**MASTER DEVELOPMENT DRAINAGE REPORT
FOR
MEADOWLAKE RANCH
SKETCH PLAN
SKP-18-004**

MARCH 2019

Prepared by:
TERRA NOVA ENGINEERING, INC
721 S. 23RD STREET
COLORADO SPRINGS, CO 80904
(719) 635-6422

PROPOSED DRAINAGE PLAN

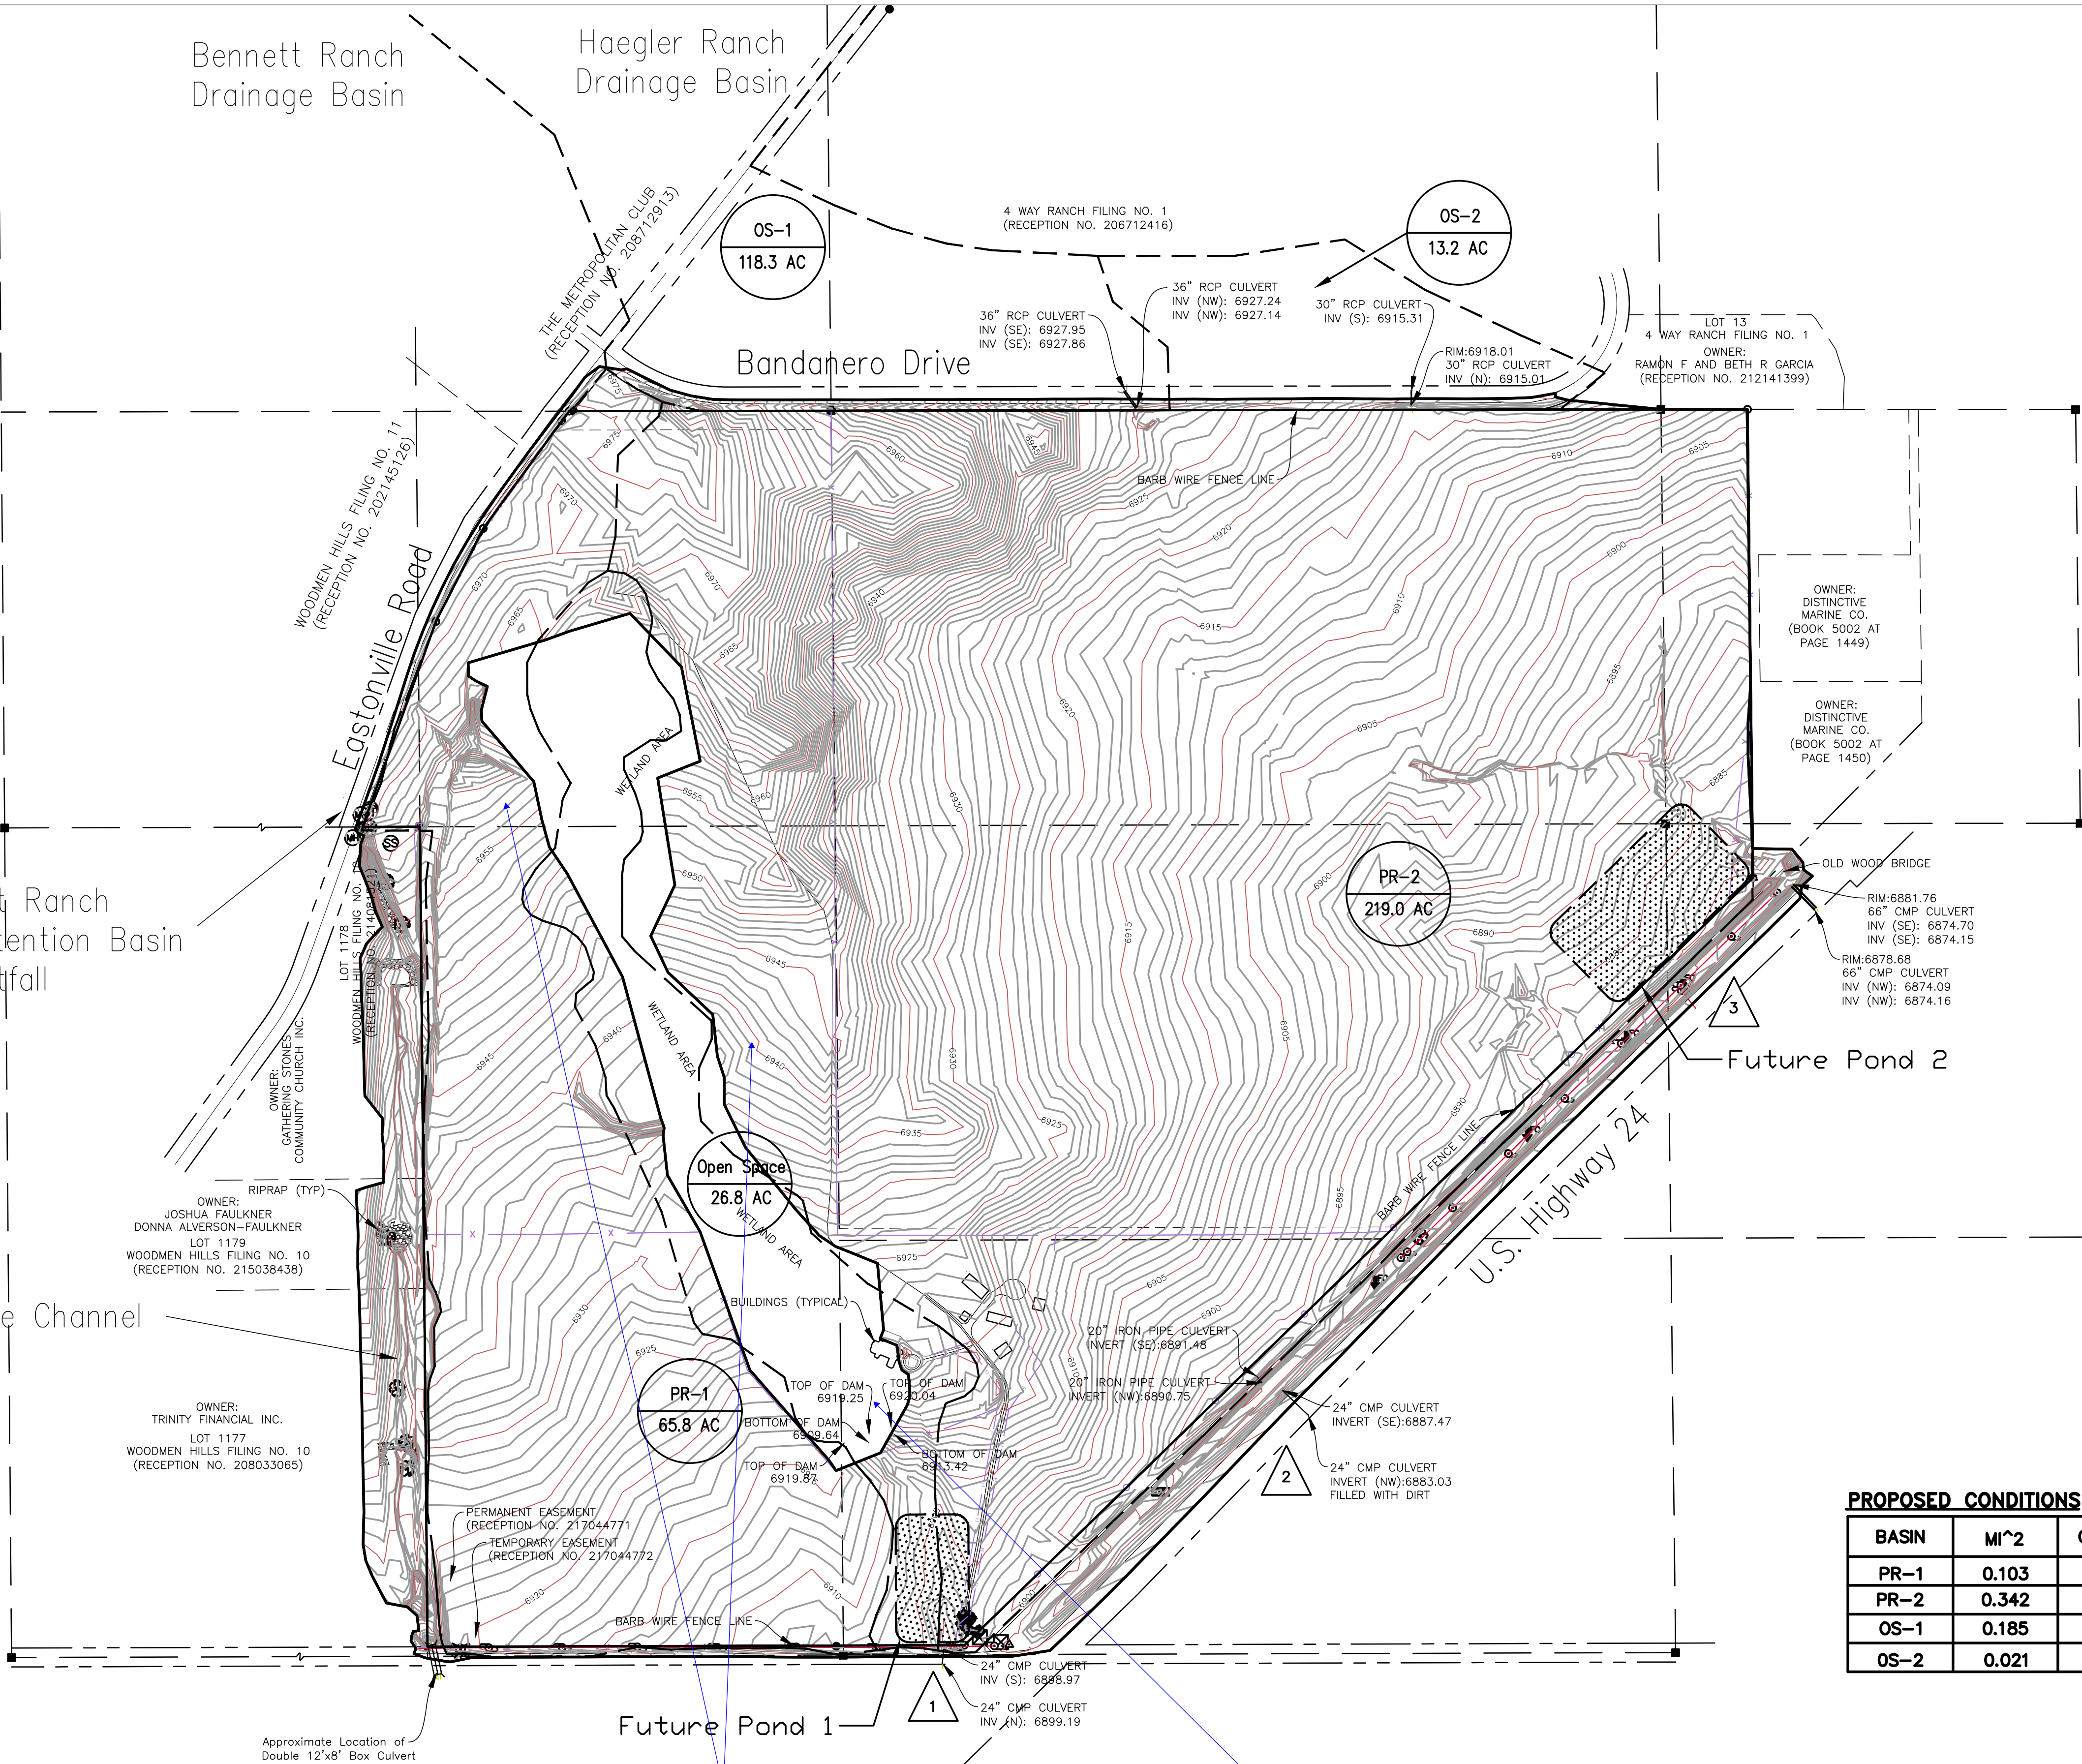
Call out the areas that
will need to be graded
to flow away from the
wetlands/open space
area to support the
proposed drainage plan
for this area.

Call out what needs to be done to
the embankments/grading/new
outfall structures etc. to support
the proposed drainage plan for
this area.
